From: Glen Donaldson (Place)
Sent: 06 July 2023 15:43
To: Planning (HPBC)
Cc: Steven Gunn-Russell
Subject: Dinting Vale HPK/2022/0456 - Transport
Attachments: 2022 11 08 22 0456 PRoW Plan(1).pdf; 20230706 Dinting Vale KCN link.docx; 20230705 Dintingresi tpcomments20220456.docx

After having an internal meeting with the relevant colleagues at the County Council on 5 July 2023, the following highway concerns we identified:

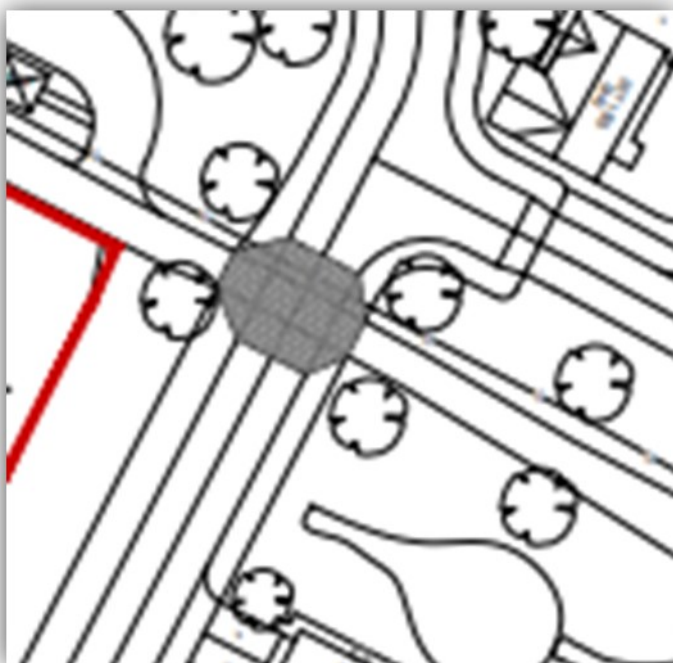
LTN/120 states: *'5.9.7 Unlike motor traffic, human physiology means that people can cycle steep gradients that are fairly short but are not capable of maintaining high levels of effort for longer distances. Cycle routes should*

therefore, where possible, be designed in such a way that the steepness and maximum length of longitudinal gradients meets the requirements of Table 5-8' with Table 5-8 having a maximum gradient of 5% (1:20).
